# Work Order ID 59266

Item Name: Basket Hoop

DESIGN #	DRAWN BY CP	DART AEROSPACE LTD HAWKESBURY, ONTARIO, CANADA	
CHECKED #	APPROVED #	DRAWING NO. D3166	REV. A SHEET 1 OF 1
DATE 02.07.10		TITLE BASKET HOOP	SCALE NTS
A	02.07.10	NEW ISSUE	
A1	04.04.08	38+/- WAS 36.0

DRAWING NO. D3166	TITLE BASKET HOOP	REV A1	DART AEROSPACE LTD ENGINEERING ORDER		D.E.O. NO. D3166-A-2	SHEET NO. 1 OF 1	SCALE NTS
DRAWN AJS	CHECKED <i>[Signature]</i>	MFG. APPR. <i>[Signature]</i>	APPROVED <i>[Signature]</i>		DE APPR. <i>[Signature]</i>		
DATE 08.12.11	DATE 08.12.15	DATE 08/12/15	DATE 08/12/16		DATE 08.12.16

**D3166-1 BASKET HOOP**

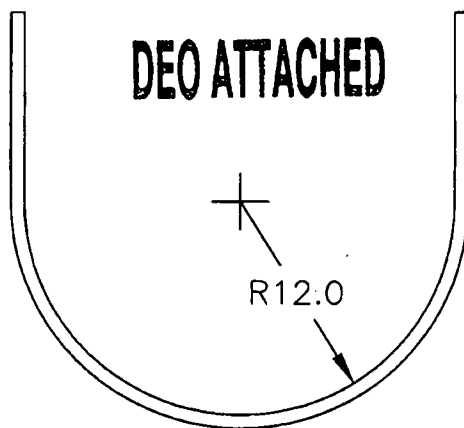
1) MODIFY MATERIAL NOTE FOR D3166-1 AS SHOWN:

WAS:

1) MATERIAL: AISI 304/316 SS SQUARE TUBING,  
0.75" x 0.75" x 0.063 WALL, 60.00" LONG  
(REF DART SPEC. M304TS0.750W.063)

IS:

1) MATERIAL: AISI 304/316 SS, 3/4 X 3/4 X 0.065 WALL SQUARE TUBING,  
60.00" LONG  
REF. DART SPEC M304TS0.750W.065

**D3166-3 BASKET HOOP**

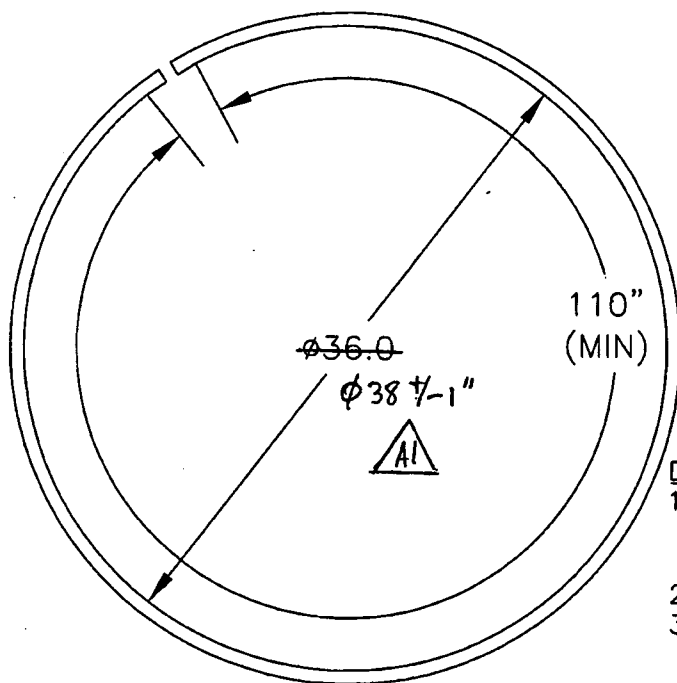
2) MODIFY MATERIAL NOTE FOR D3166-3 AS SHOWN:

WAS:

1) MATERIAL: AISI 304/316 SS SQUARE TUBING,  
0.75" x 0.75" x 0.063 WALL, 120.00" LONG  
(REF DART SPEC. M304TS0.750W.063)

IS:

1) MATERIAL: AISI 304/316 SS, 3/4 X 3/4 X 0.065 WALL SQUARE TUBING,  
120.00" LONG  
REF. DART SPEC M304TS0.750W.065
